Subject: A/T SHIFT LEVER IS HARD TO MOVE	Bulletin No: 05-009/14
	Last Issued: 08/29/2014

2014 Mazda6 with VINs lower than JM1GJ*****162912 (produced before Dec. 3, 2013)

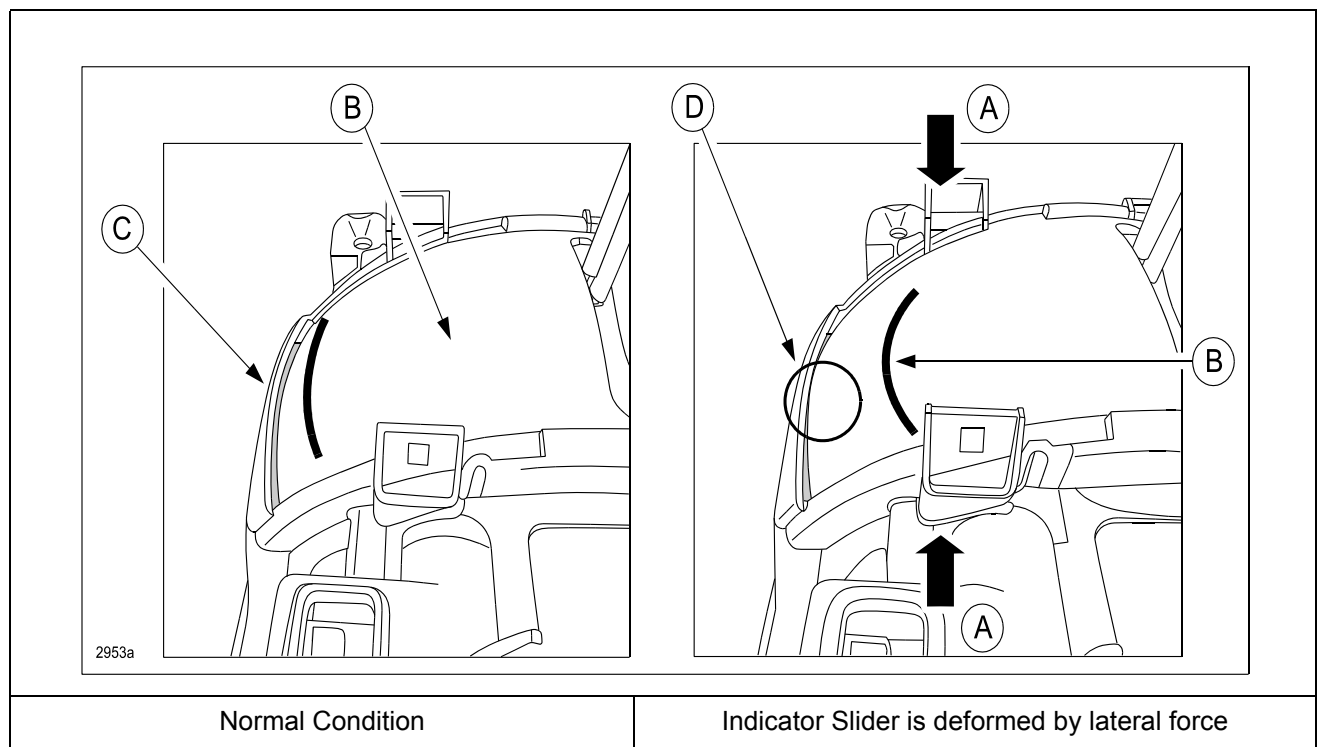
When the driver or front passenger's leg contacts the center console, lateral force (A) may deform the indicator slider (B), causing the slider edge to contact the arched part of the set plate (D). This may cause damage to the indicator slider (B) and/or hard A/T shift lever movement.
